SLG46108-EV Errata Note

This document contains the known errata for SLG46108-EV and the recommended workarounds.

Figure 1. Testing Design and Settings

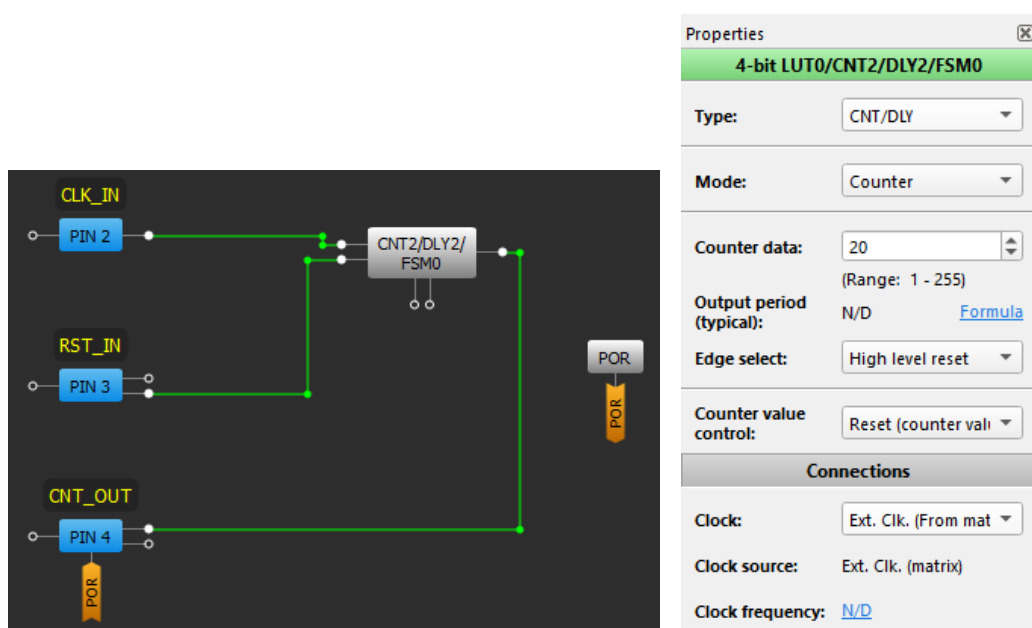
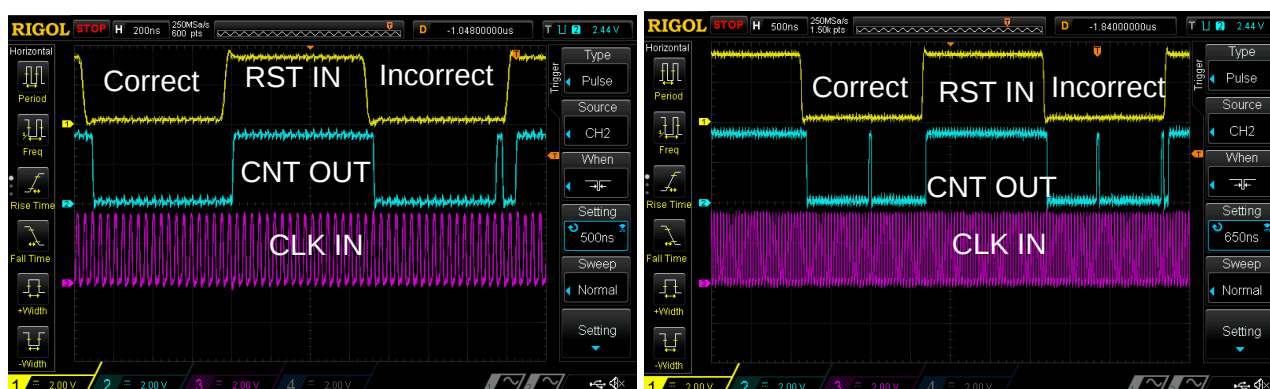
If the Counter Reset is asserted at the same time as a rising clock edge, it is possible that the Counter Data will be reset incorrectly and the counter output may appear faster than expected, it doesn't depend on the edge select option. This phenomenon appears more often as the clock frequency increases.

Synchronize the RESET input of the Counter with its CLK using 2 DFF cells as shown in [Figure 3](#).

Figure 5. OSC Accuracy vs. Pass-Through Signal Frequency

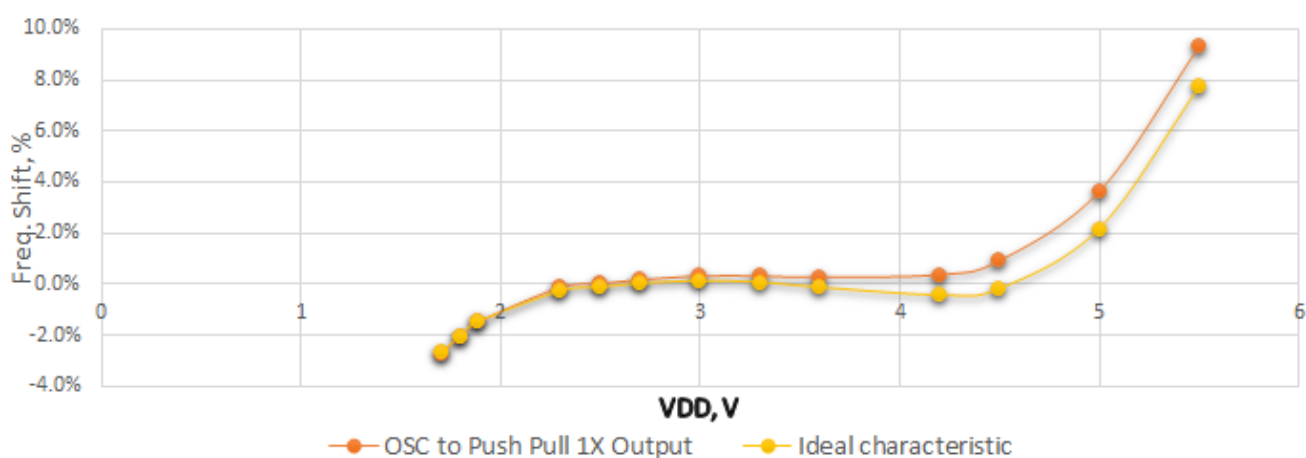
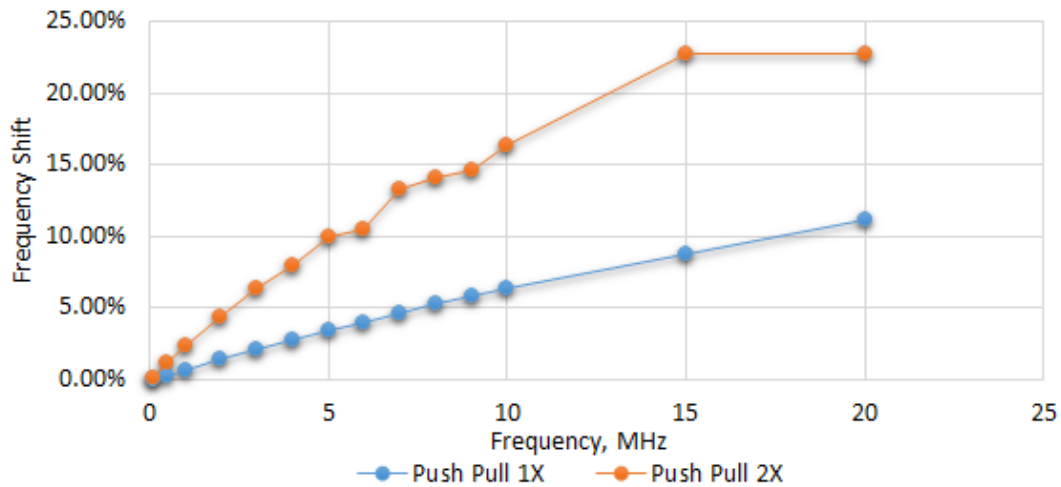
While applying some high-frequency noise to the V_{DD}, OSC inaccuracy may increase. The same behavior is also present in cases where high-frequency switches are outputted from the chip using the Push-Pull type driver. See, the test results in [Table 1](#).

- Only use frequencies lower than 2 MHz when switching the output.
- Do not use parallel PIN connections to output high-speed switching signals.

Figure 6. Testing Design

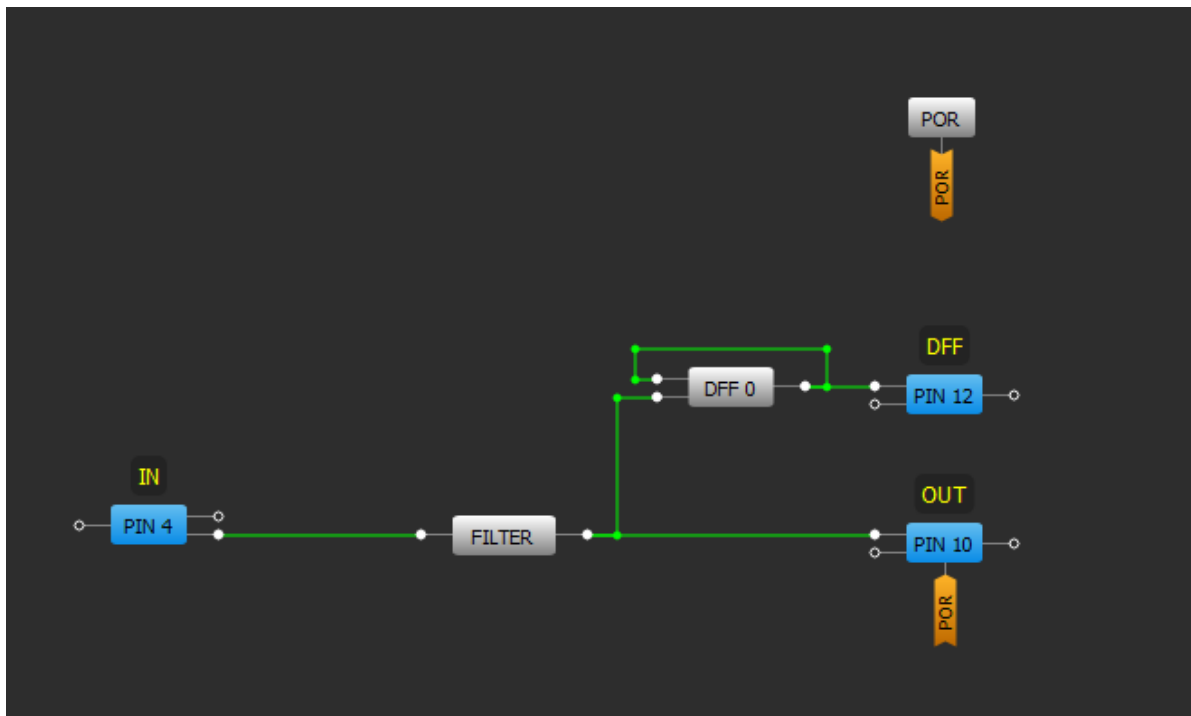
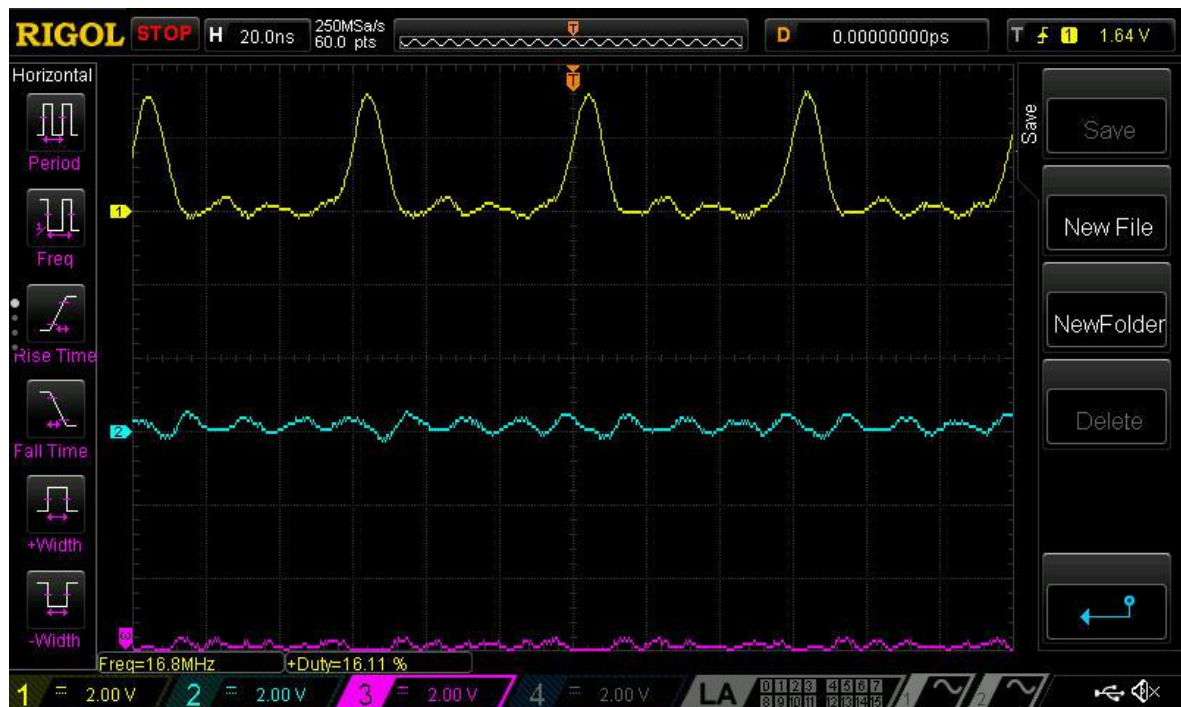
If high-frequency clock input comes in, the FILTER cell may not filter out it. There are several factors like input frequency, duty cycle, and LOW duration in such signal that may lead to its passing through the FILTER block.

Currently, there is no workaround for this issue. Filter block is good at filtering short spontaneous glitches. It is intended to be used in a series connection before the delay cell to avoid its latching.

Figure 11. Problem Trigger Pattern

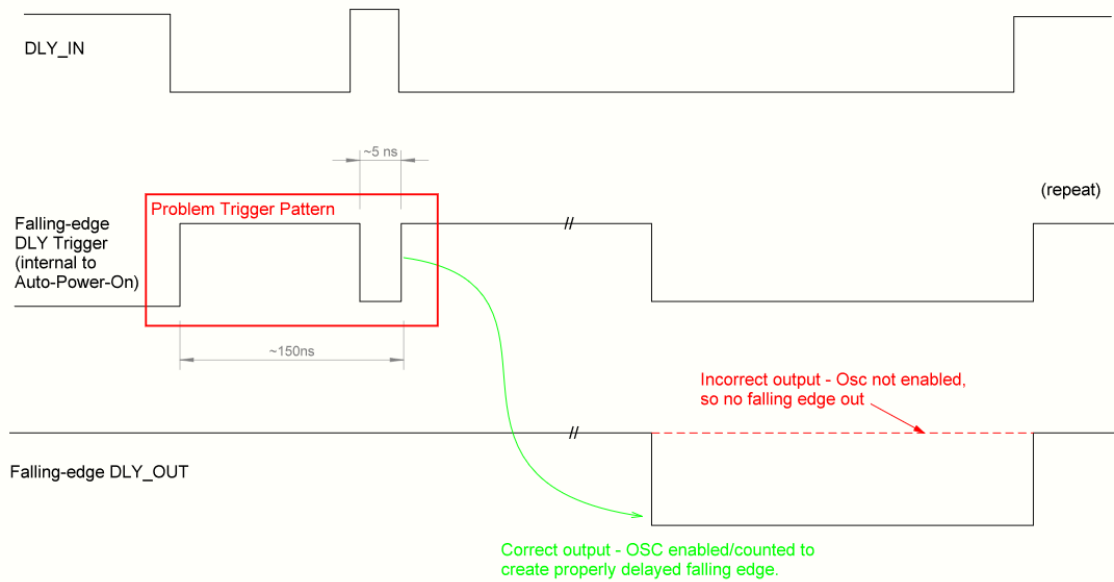
For this chip, the Auto Power On circuitry of the 25 kHz/2 MHz generators contains a circuit errata, which can potentially fail to power on the OSC for a specific pattern and timing of the OR of all related DLY trigger signals. The pattern is shown in [Figure 11](#) (boxed in red) and consists of a relatively longer pulse (~145 ns) followed by a shorter (~5 ns) glitch of opposite polarity.

- Use signal conditioning circuits to prevent glitches on DLY inputs < 200 ns. Examples:
 - ACMP with Hysteresis
 - External RC in front of Digital Input with Schmitt Trigger
 - Filter cell.
- Set OSC power mode to Force Power On mode instead of Auto Power On.
- Use a different oscillator, such as 25 MHz Ring OSC, which does not have Auto Power On issue.

Figure 12. Test Circuit

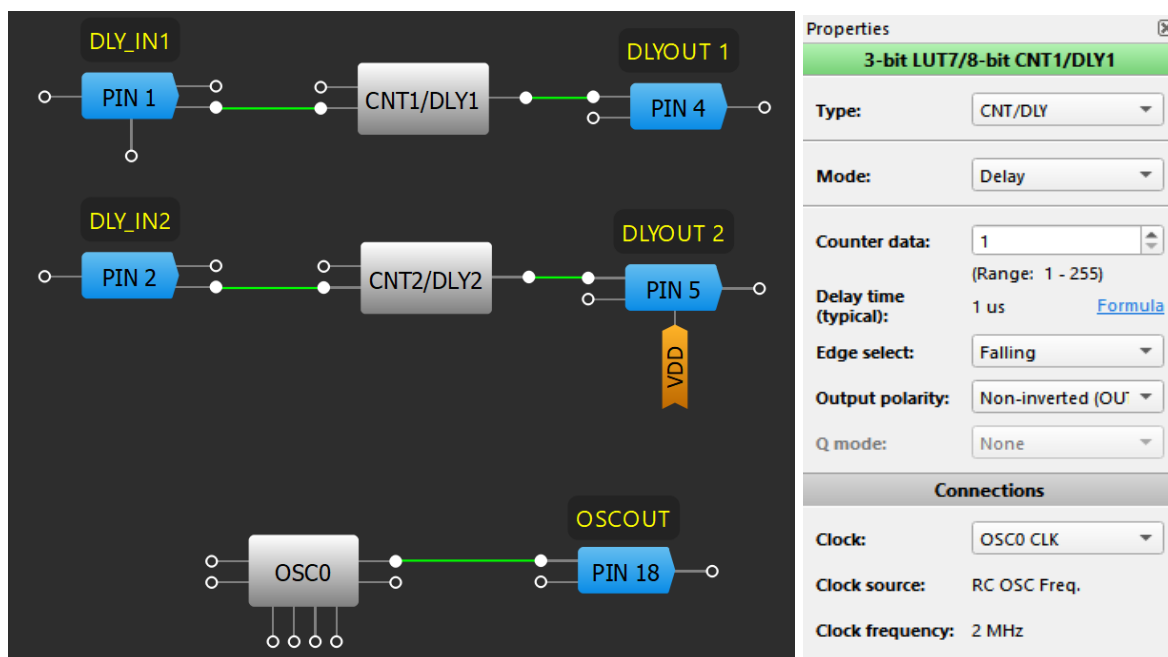
The error is difficult to capture as the timing must be exact within ns, and short (ns) pulses are difficult to generate glitches precise enough to induce the problem. GPIO naturally filters out ns pulses, so for purposes of errata capture, two simultaneous falling-edge DLY circuits (as shown in [Figure 12](#)) were used. By lining up two delays precisely at a particular timing relationship, we can use the internal Auto Power On (OR logic) to generate the glitch pattern necessary to cause the error.

Figure 13. Errata Capture (Zoom Out)

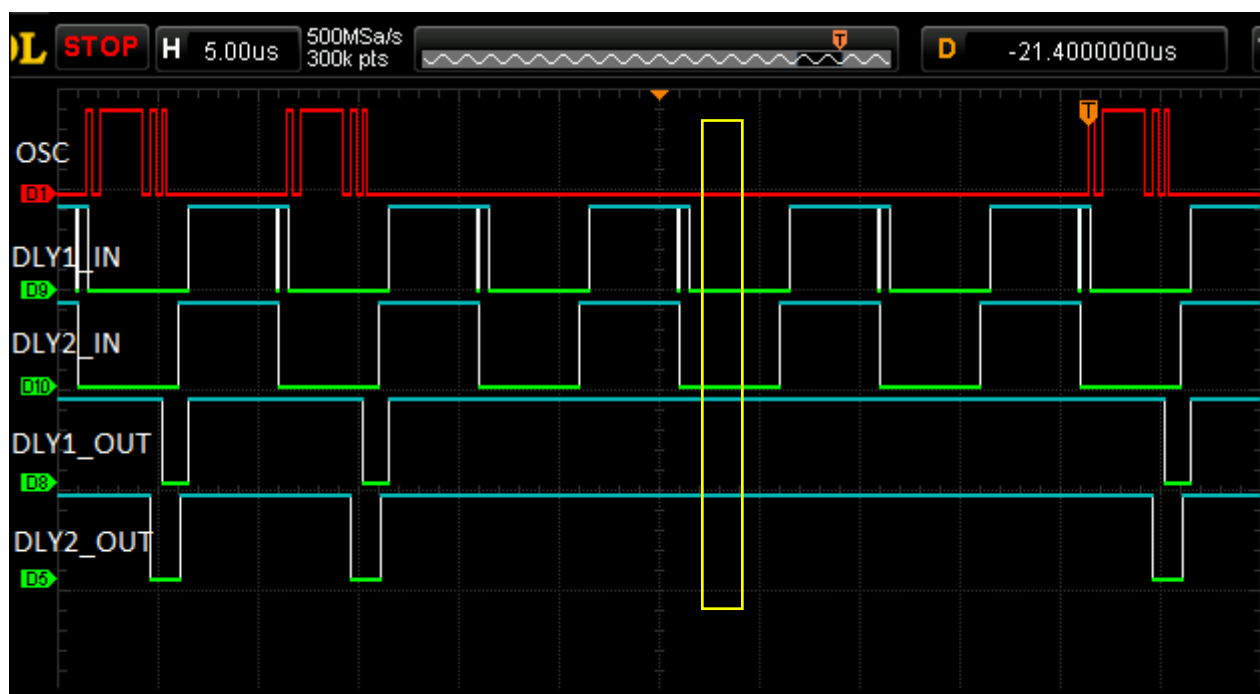
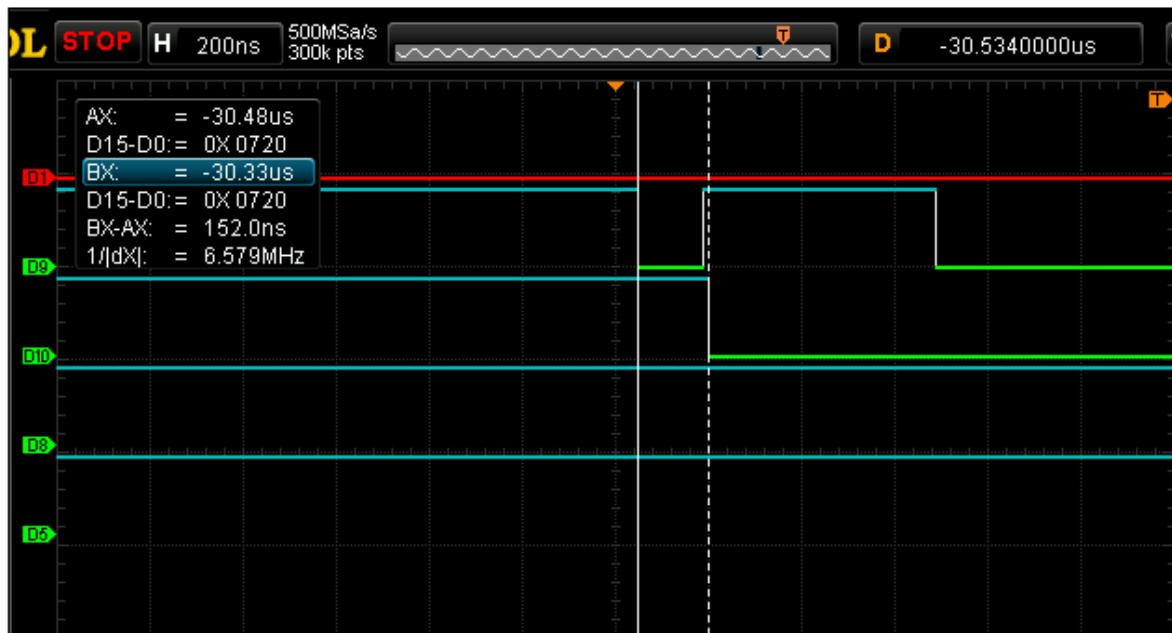
Figure 13 shows a series of DLY output events are missing, where the OSC is correspondingly not triggering when it was supposed to. Figure 14 is a zoom-in of the boxed region from Figure 13. The total glitch/chatter time was measured in this case at 152 ns. By using the composite OR of the two delay channels, we can asynchronously strobe with tiny frequency variations, and so tune the timing to induce this errata. Note that the error is not persistent – the system is recovered when all DLYs are returned to inactive state, such as when input of falling edge DLY goes high, thus canceling delay, or after DLY out finishes.

Figure 15. Test Design

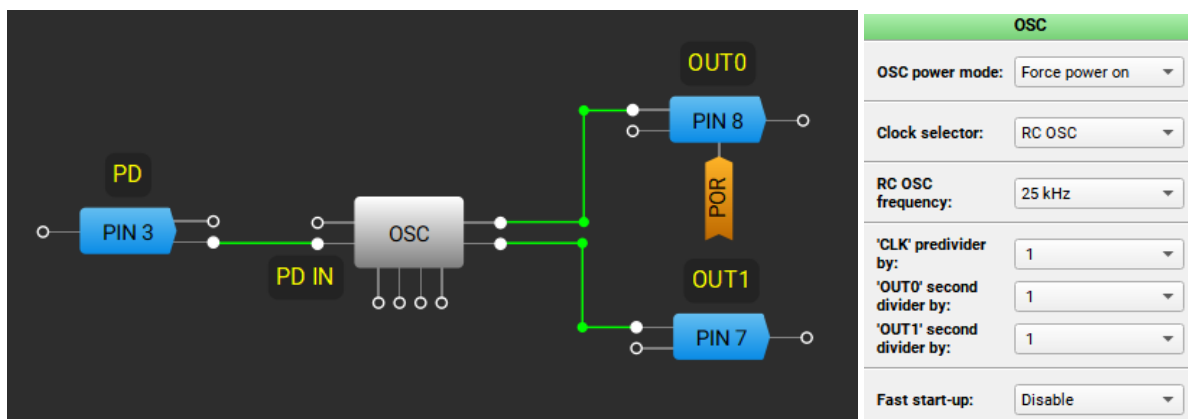
When a short pulse is applied to the PWR DOWN input, the oscillator exhibits a long start-up time.

When a short pulse of less than ~40 ns is applied to the PWR DOWN input.

Change the Fast Start-up setting to "Enable" (see [Figure 18](#)) or avoid applying glitches to the PWR DOWN input of the oscillator.
